Advisory Board on Radiation and Worker Health
National Institute for Occupational Safety and Health

**Focused Review of ORAUT-RPRT-0092, Revision 00, and
Remaining Petition SEC-00103 Evaluation Report Period:
1991–2007**

**Contract No. 75D30119C04183
Document No. SCA-TR-2022-SEC001, Revision 0**

Figure 1. Fraction of total mandated bioassays that were listed on the RWP versus year

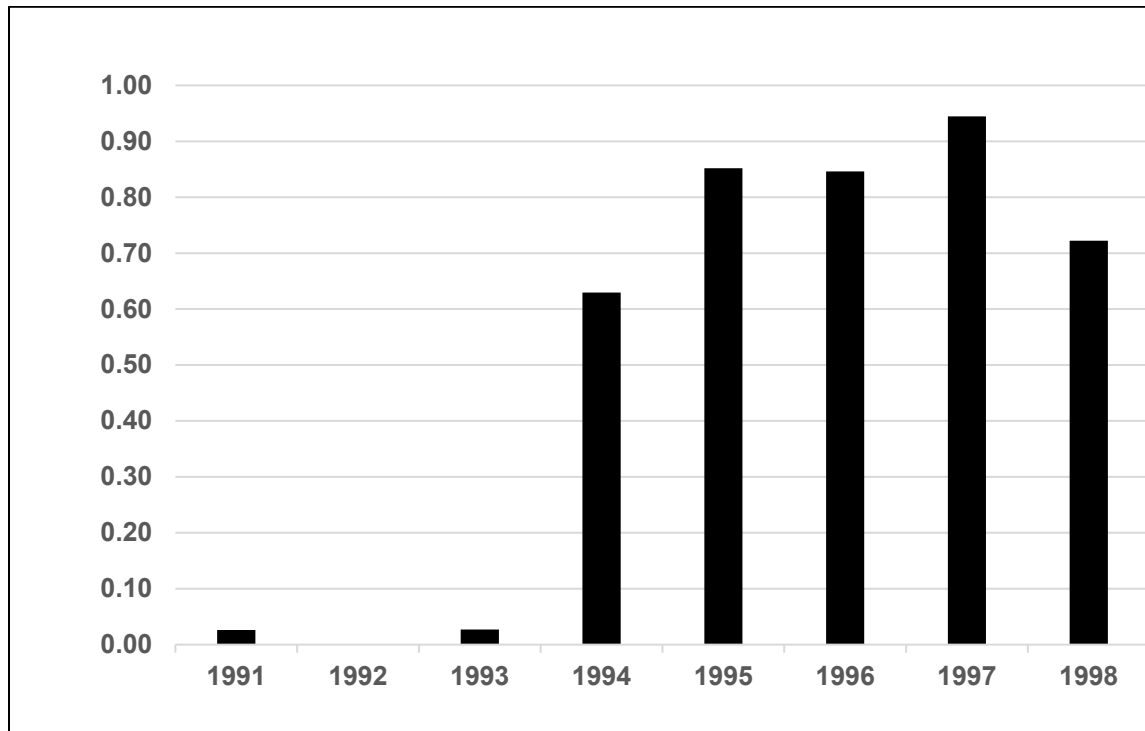
SC&A analyzed the data in table C-1 of RPRT-0092 to determine when RWPs began to state if a bioassay was necessary, and the types of radionuclides that should be bioassayed. SC&A sorted the data in table C-1 according to the year of the RWP (1991–1998) and determined the total number of radionuclide bioassays mandated by adding the number of bioassays specifically required by an RWP (represented by the symbol “R” in table C-1) plus the number assumed to be needed by NIOSH (represented by the symbol “A” in table C-1). The number (R) of bioassays specifically stated on the RWP was then divided by the total number (R + A) of mandated bioassays to obtain the fraction of bioassays mandated in RPRP-0092 that were specifically required on the RWPs. The results for 1991–1998 are shown in figure 1.

The results in figure 1 and table 2 indicate that RWPs began to specify that a bioassay was required for certain radionuclides in the mid-1990s (1994 to 1995).

Figure 2. Figure 4-4 from RPRT-0092: attachment 2 to root cause analysis corrective action report

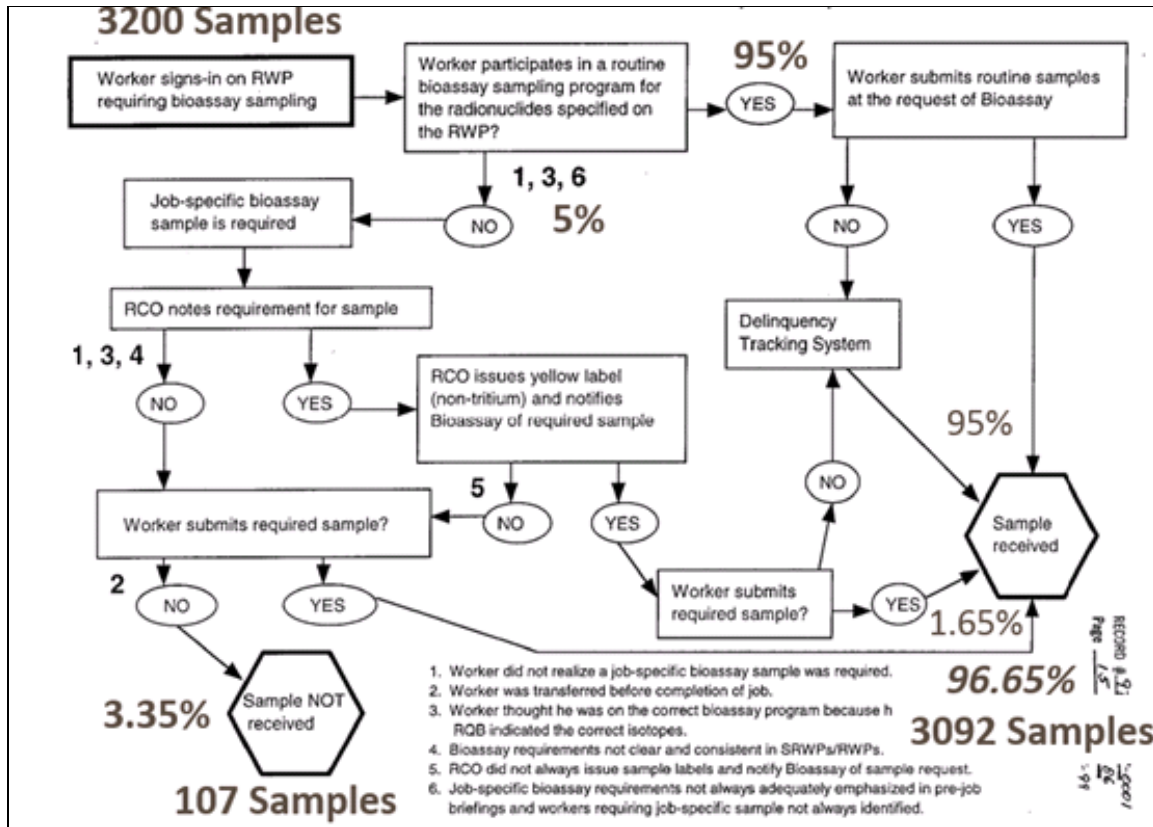
A more significant issue is that the data used in RPRT-0092 appear to have failed to identify the missed job-specific bioassays as outlined in figure 4-4, page 39, of RPRT-0092 (NIOSH, 2019a; reproduced here as figure 2), which was taken from WSRC (1998d). The flowchart is the expected process; the large numbers represent actual first four months of 1997 participation as analyzed in May 1997 (NIOSH, 2019a, p. 38).

Figure 3. Percent of directly and effectively monitored sCTWs per RWP-mandated bioassays (R + A)

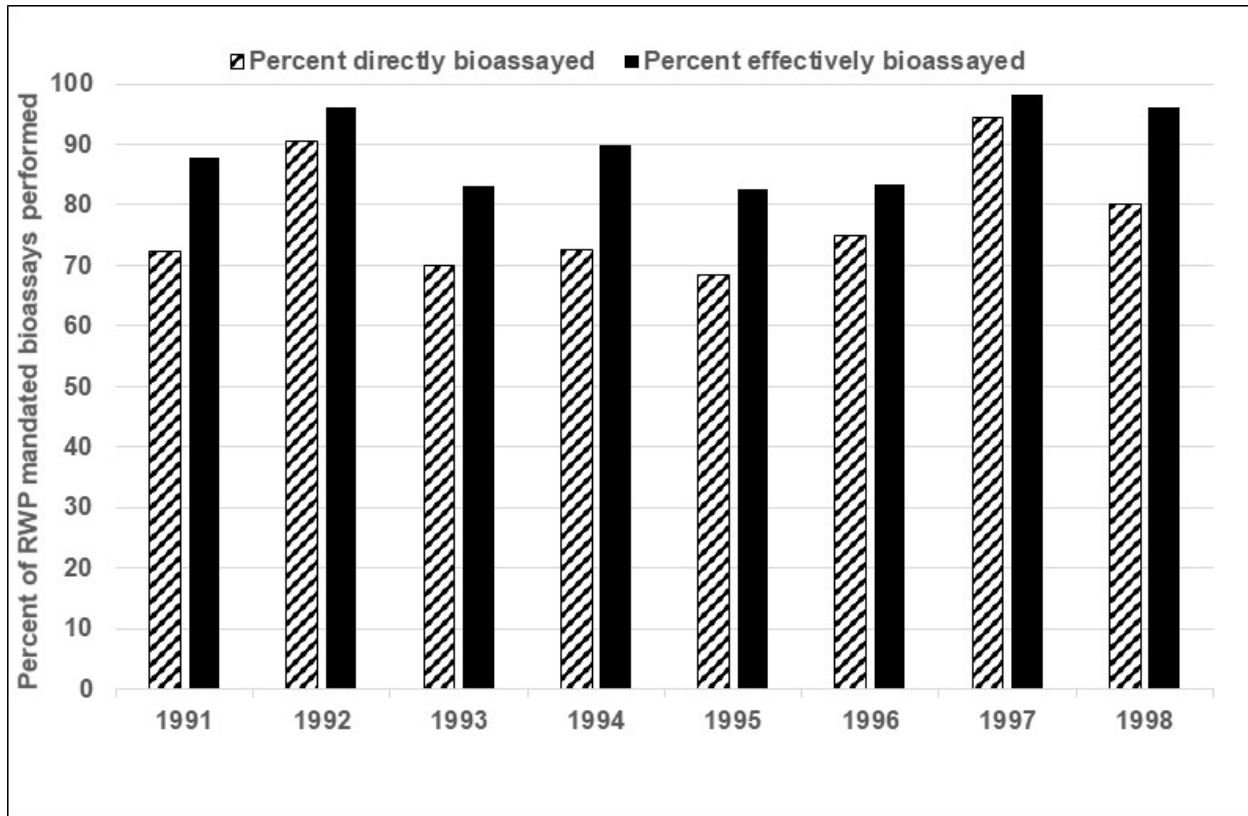
SC&A analyzed the data in RPRT-0092 to determine the percentage of sCTWs bioassayed for the total number of mandated bioassays (R + A) for an RWP when all mandated radionuclides are needed for the sCTW to be considered monitored. The results for both directly and effectively monitored sCTWs are shown in figure 3. The percent values are similar to those in tables 10 and 12 of SC&A's RPRT-0092 review (SC&A, 2019a).

However, the mostly routine bioassay data tend to overshadow the missed sCTW job-specific bioassays, such as those in the set of 107 missed bioassays during the first four months of 1997, as referred to in figure 4-4 and page 38 of RPRT-0092. The much lower number of job-specific bioassays would not have the potential to provide a significant impact on the overall percent monitored.

Figure 4. Directly bioassayed radionuclides with 1991–1994 noncompliance fraction greater than 1995–1998 noncompliance fraction

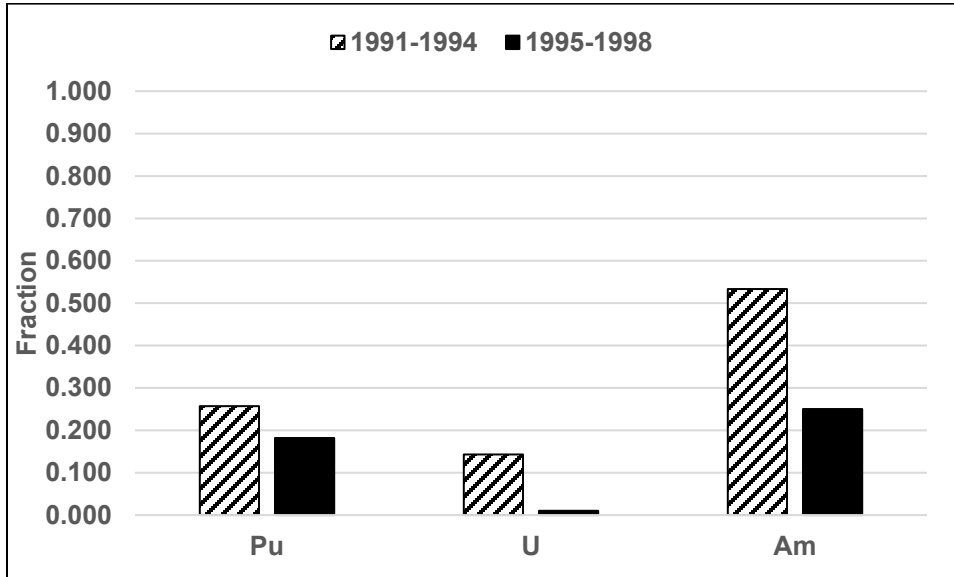
SC&A further analyzed the results in terms of noncompliance as a function of radionuclide and year. For the purpose of this exercise, SC&A selected <80 percent as an arbitrary threshold for direct bioassay monitoring for an area or building, below which compliance would certainly be questionable. SC&A divided the results into two periods, 1991–1994 and 1995–1998, to see if there was any obvious step function that would indicate a greater compliance rate after 1994 when RWPs began to be more prescriptive. However, there does not appear to be a defining inflection point. Figures 4 and 5 summarized the results for sCTWs directly monitored. In these two figures, a high fraction of missed bioassay results means poor compliance. The results were mixed. For example, bioassay noncompliance was greater for plutonium, uranium, and americium for 1991–1994 (taller hashed bars) compared to 1995–1998 (shorter black bars) as shown in figure 4, but Sr/FPs and neptunium bioassay noncompliance was greater for 1995–1998 (taller black bars) compared to 1991–1994 (lower hashed bars) as shown in figure 5. However, there were only three RWPs with 11 workers for 1995 for neptunium. Americium and neptunium had a greater amount of noncompliance (ranging from 20 to 100 percent) compared to plutonium, Sr/FPs, and uranium (noncompliance ranged from zero to 24 percent), perhaps because plutonium, Sr/FPs, and uranium were more likely to be covered by routine bioassays whereas americium and neptunium radionuclides were not as common (and more likely to be on job-specific bioassays). As mentioned previously, for some radionuclides there was an insufficient number of RWPs in the 1995–1998 period to provide statistically significant results.
